Access Compliance Report Public Rights-of-Way (Curb Ramps)

Intersection ID: 28211 Main Street: AUTUMN_APPLAUSE_DR Cross Street: STAGS_LEAP_CT Location: NW
ADA ID: D9335B51FA24 Ramp Type: PerpDiag Initial Pass/Fail: Fail Overall Compliance: No Severity Score: 35

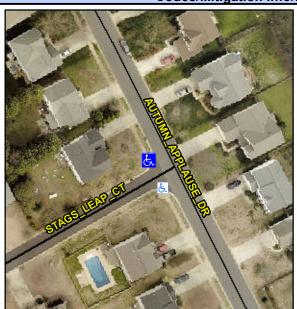
Not Found, R304.5.1

Fleid Measurements/Component Compliance					
Compliance Description		Data	Compliance Description		Data
N/A	A Ramp Length (in)	96.0	Yes	Ramp Slope (%)	6.9
No	Ramp Width (in)	28.0	Yes	Ramp XSlope (%)	1.8
N/A	Flare Type LT	N/A	N/A	Flare Type RT	N/A
N/A	Flare Slope LT (%)	N/A	N/A	Flare Slope RT (%)	N/A
N/A	Flare Traversable LT?	N/A	N/A	Flare Traversable RT?	N/A
N/A	Landing Length (in)	N/A	N/A	DWS Provided?	N/A
N/A	Landing Width (in)	N/A	N/A	DWS Contrast?	N/A
N/A	Landing Slope (%)	N/A	N/A	DWS Length (in)	N/A
N/A	Landing X Slope (%)	N/A	N/A	DWS Full Width?	N/A
N/A	Landing Curb? (Y/N)	N/A	N/A	DWS Offset (in)	N/A
N/A	A Shared Landing?	N/A			
N/A	Gutter Ponding?	N/A	N/A	Gutter Slope (%)	N/A
N/A	Gutter Lip Ht (in)	N/A	N/A	Gutter X Slope (%)	N/A
N/A	A Painted X Walk1?	No	N/A	Painted X Walk2?	No
	X Walk 1 Direction	To S		X Walk 2 Direction	To E
N/A	X Walk 1 Width (in)	N/A	N/A	X Walk 2 Width (in)	N/A
	X Walk 1 Slope (%)	0.1		X Walk 2 Slope (%)	2.6

Remove & Replace Curb Ramp With Two New Directional Ramps or Equivalent.
